**From:** [Sartori, Aline](#)  
**To:** [Ingrid Allen](#)  
**Subject:** RE: PB-1426 Proposed Minor Alterations - Request for NMR Letter  
**Date:** Tuesday, October 8, 2024 1:02:45 PM  
**Attachments:** [image004.png](#)  
[image008.png](#)  
[image009.png](#)

See attached newly proposed sheet IR-1 submitted to Town. As you can see, certain irrigation previously approved by FDEP that extends eastward of the dune area has now been removed. I just want to make sure that these modifications do not change the validity of FDEP's permit.

**Landscape Plan  
NEW RESIDENCE**  
3521 S Ocean Blvd., Highland Beach, FL 33487

IRRIGATION PLAN

Last Date: 08-16-2024

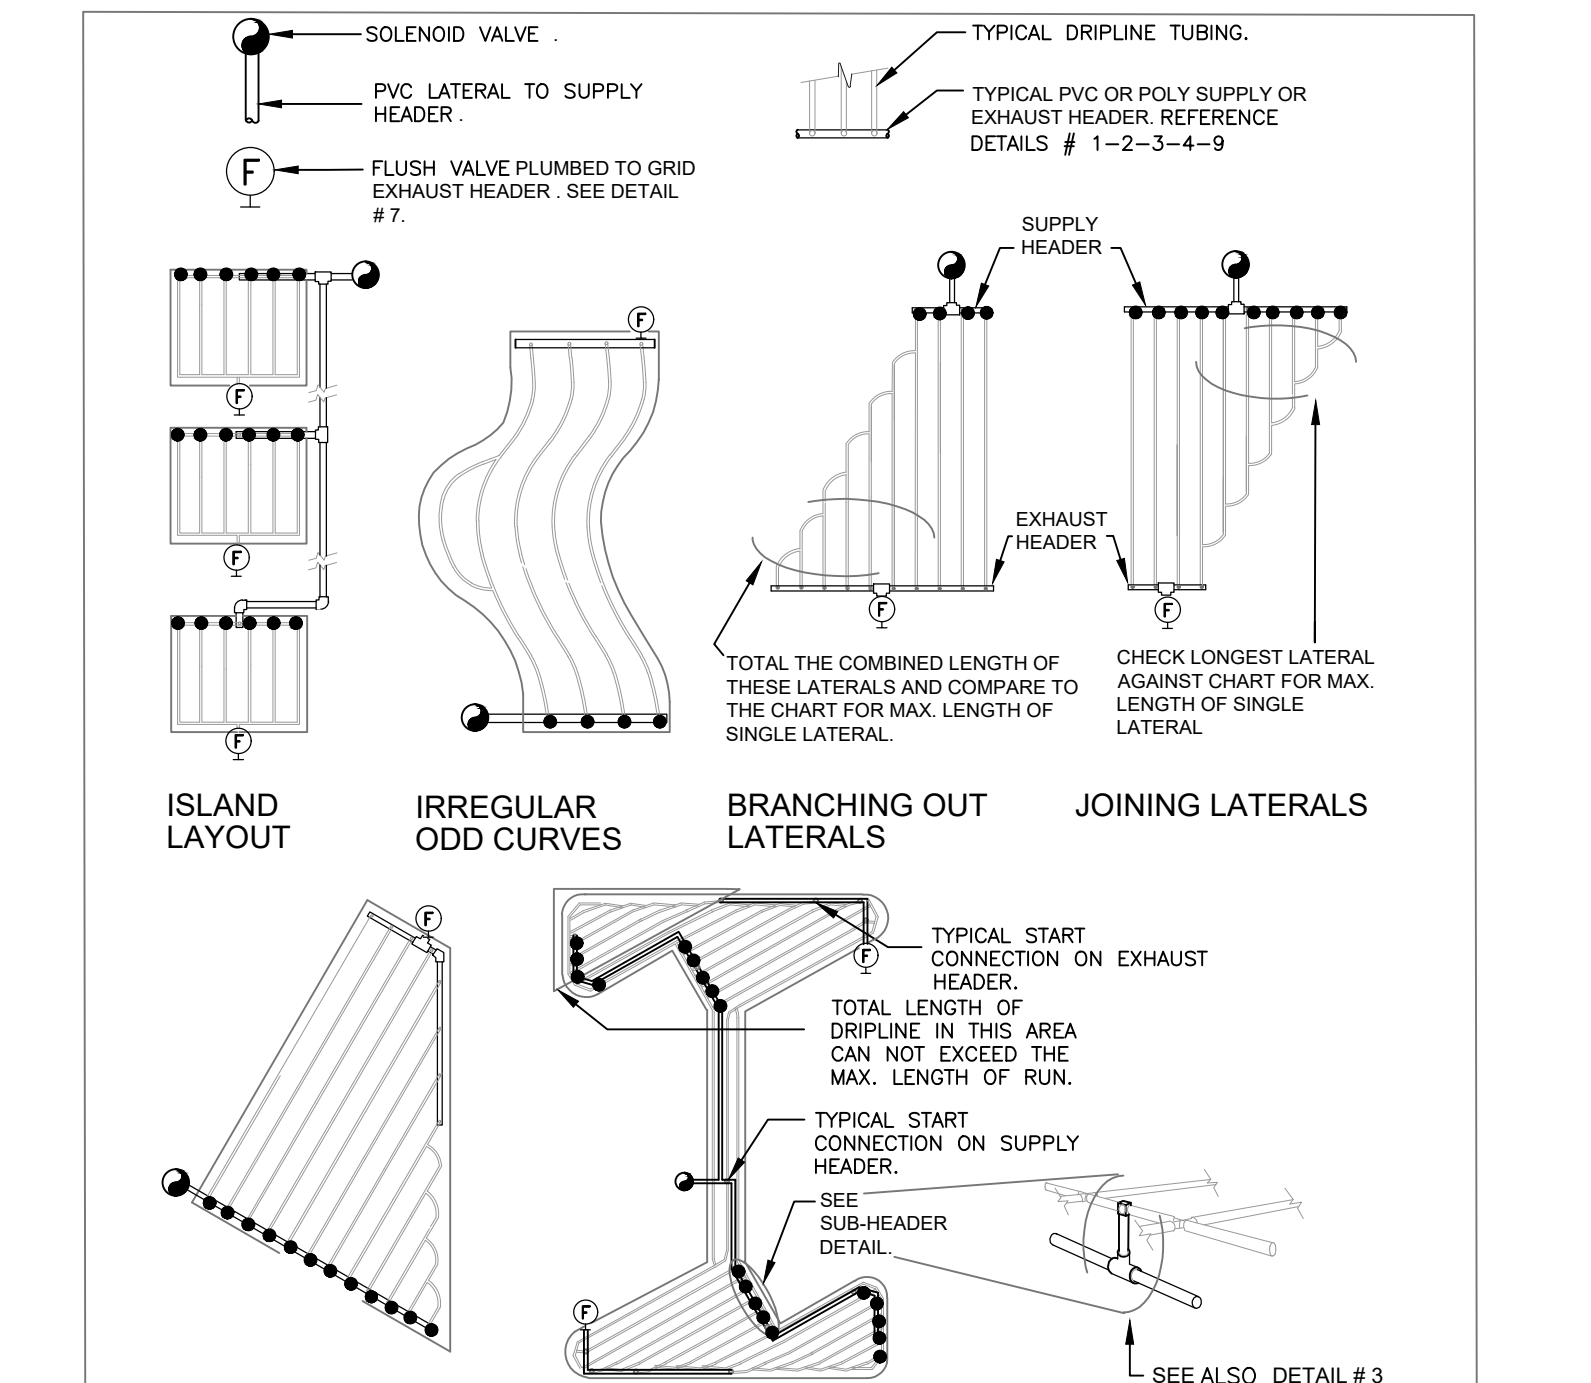
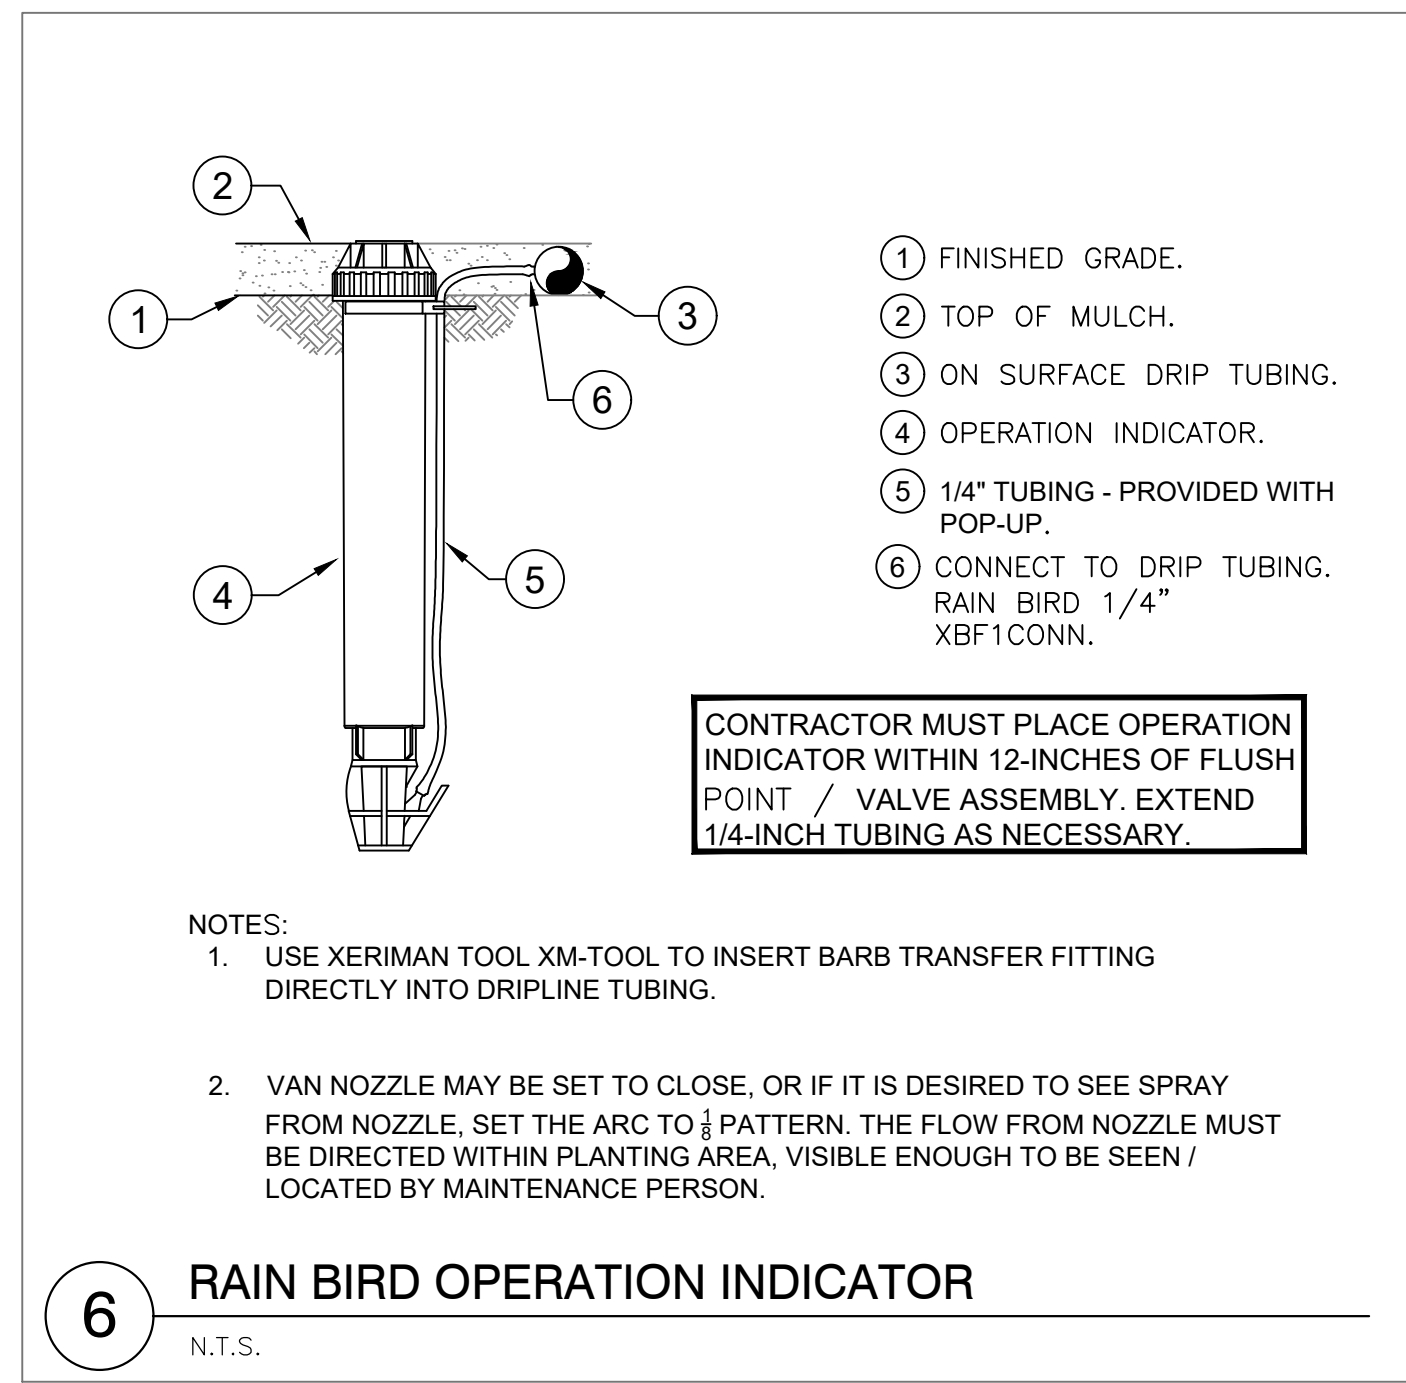
Hoping you can assist regarding above-referenced permit. The applicant's Irrigation plan sheet IR-1 (see attached "Landscape Plan") which FDEP previously approved is now being revised by the Applicant. The newly proposed sheet IR-1 submitted to the Town (see attached) has changed whereby certain irrigation in the dune vegetation has now been removed. Kindly advise if this removal affects the validity of the permit.

**DELTA 1 (IRRIGATION MODIFIED)**  
**SPRAY HEADS, DRIP LINE, and BUBBLERS**

TURF HEADS ON THE NORTH SIDE OF DRIVEWAY WERE MODIFIED TO ACCOMMODATE A LARGER TURF AREA.

TURF SPRAY HEADS ON EAST SIDE OF THE HOUSE WERE MODIFIED TO ACCOMMODATE A LARGER TURF AREA.

TURF SPRAYS HEADS WERE MODIFIED ON THE SOUTH SIDE OF MAIN ENTRANCE TO THE HOUSE TO ACCOMMODATE THE NEW LANDSCAPE LAYOUT.

TURF SPRAY HEADS WERE MODIFIED ON THE SOUTH SIDE OF DRIVEWAY TO THE HOUSE TO ACCOMMODATE A SMALLER TURF AREA.

DRIPLINE LAYOUT WAS MODIFIED ON THE WEST SIDE OF THE PARKING AREA OF ACCOMMODATE THE REDUCED PLANTING AREA.

DRIPLINE LAYOUT WAS MODIFIED ON THE SOUTH SIDE OF THE MAIN ENTRANCE OF THE HOUSE TO ACCOMMODATE THE NEW LANDSCAPE LAYOUT.

ONE BUBBLER WAS REMOVED FROM THE PLANTING AREA TO THE WEST OF THE PARKING.

THE VALVES ALONG THE NORTH PROPERTY LINE HAVE BEEN RECONFIGURED TO ACCOMMODATE THE REVISED LANDSCAPE DESIGN. THE ORIGINAL PALM AND NEW BOTH HAVE 6 VALVES ALONG THIS PROPERTY LINE BUT THE SPACING HAS BEEN MODIFIED.

THE ORIGINAL PLAN HAD ONE VALVE ON THE EAST SIDE OF THE HOUSE AND THE NEW PLAN HAS ONE ON THE EAST SIDE OF THE HOUSE.

THE ORIGINAL PLAN HAD 10 VALVES ALONG THE SOUTH PROPERTY LINE. THE NEW PLAN HAS 4 VALVES ALONG THE SOUTH PROPERTY LINE TO ACCOMMODATE THE MODIFIED LANDSCAPE LAYOUT.

THE ORIGINAL PLAN HAD 1 VALVE WEST OF THE PARKING AREA AND THE NEW PLAN HAS 2 VALVES TO ACCOMMODATE THE NEW LANDSCAPE LAYOUT.

**DELTA 2 (VALVE SCHEDULE MODIFICATIONS)**  
 THE ORIGINAL PLAN HAD A TOTAL OF 18 VALVES AND THE NEW PLAN HAS A TOTAL OF 14 VALVES.

**DELTA 3 (WATERING SCHEDULE MODIFICATIONS)**  
 THE ORIGINAL PLAN HAD A TOTAL OF 18 VALVES IN THE WATERING SCHEDULE WITH A TOTAL GALLON PER DAY OF 1,554. THE NEW PLAN HAS A TOTAL 14 VALVES WITH A TOTAL GALLON PER DAY OF 1,573.

These modifications will not affect the validity of the permit.
